M60J SCHEMATIC Revision 2.00

Title : NB ****	
ASUSTek COMPUTER INC. NB1		Engineer: James1_Wu	
Size	Project Name		Rev
Custom	M60J		2.00
Date: Thursday, July 02, 2009	Sheet 8 of 99		1

DDR3 Vref

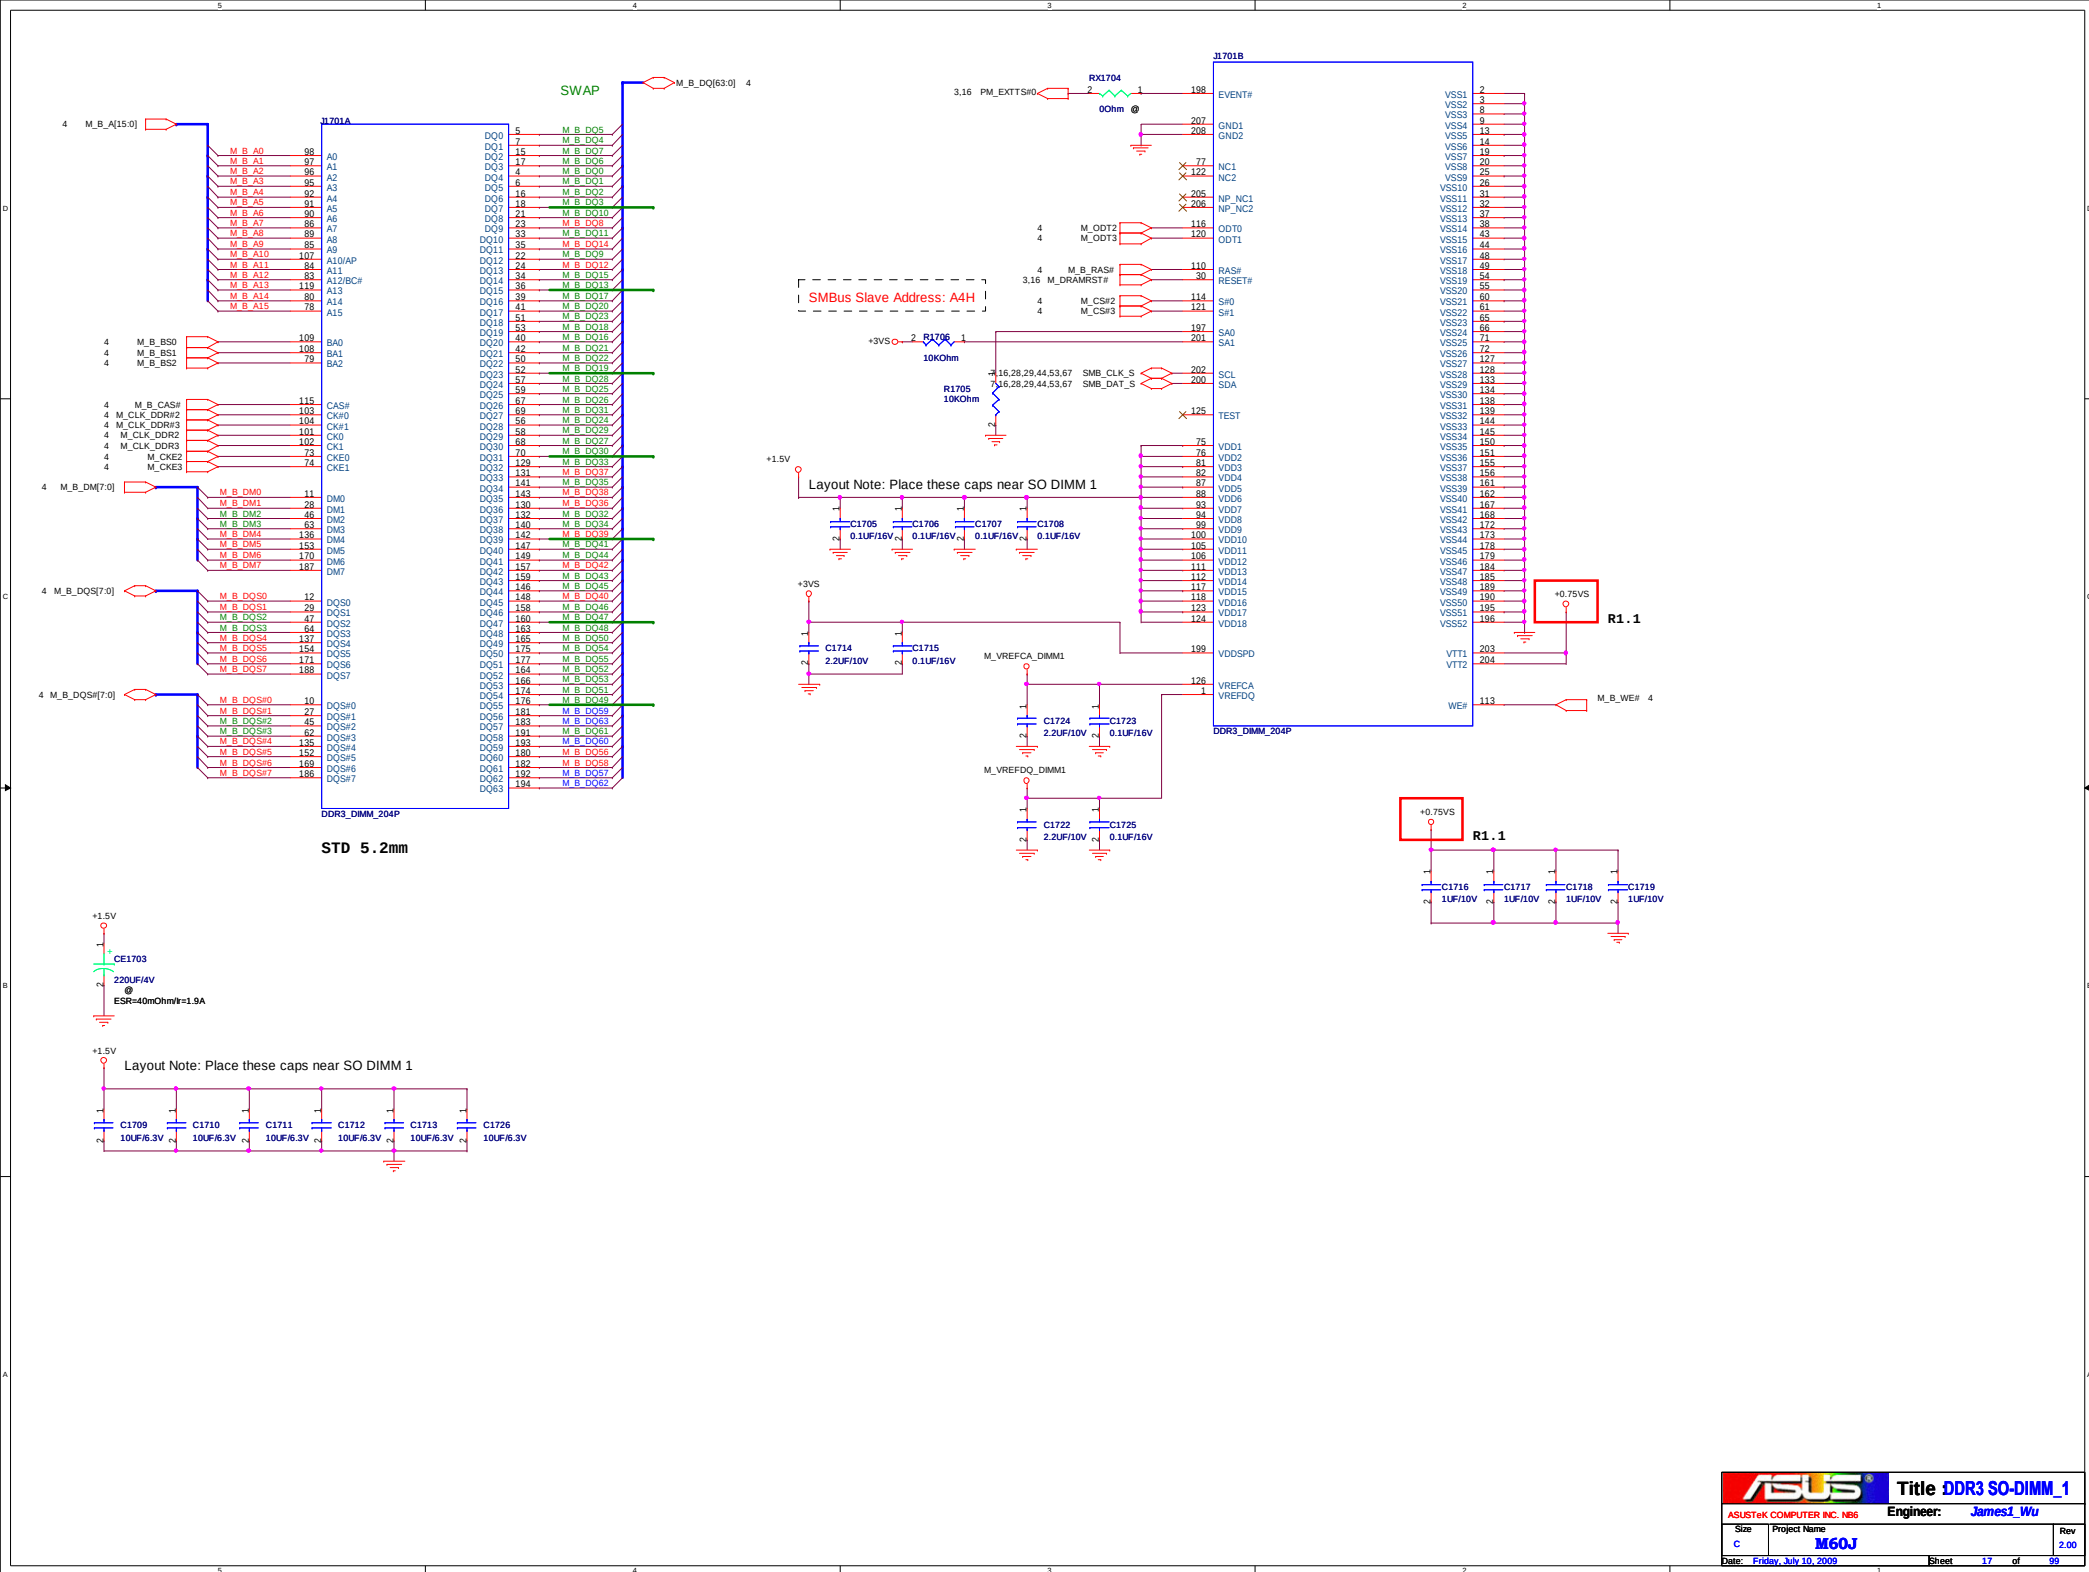
Default M1 →

M1: Fixed SO-DIMM VREF_DQ (Default Stuffing)

For Arrandale only designs: Only method M1 should be enabled.
For Clarksfield only designs: Both M1 AND M3 methods should be enabled.
For Common Motherboard designs: Both M1 AND M3 methods should be enabled

**M3: Processor Generated SO-DIMM VREFDQ
- New Requirement**

R1.3,item L3

*Option: Mount=R1801,R1802,R1803,R1804,R1809
Unmount=R1805,R1806

Option: Mount=R1802,R1803,R1805,R1806,R1809,
Unmount=R1801,R1804

PC BEEP

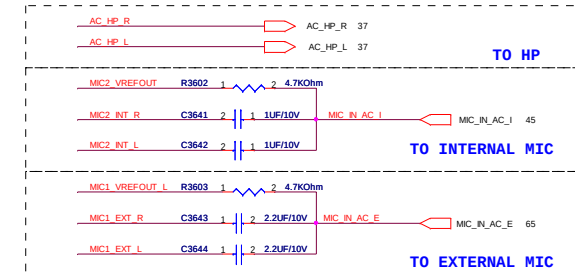
Remove PC_BEEP Circuit
Please remove the PC Beep function from Verb table.

CPU Thermal Sensor

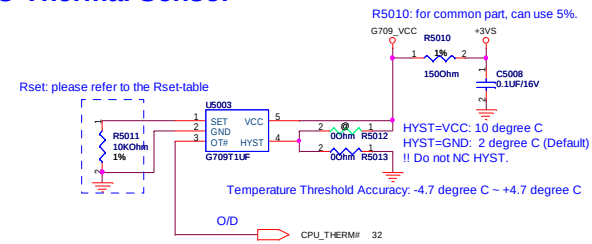
R2.00,item L15

Layout note:
Place U5003 at the center of the CPU socket.
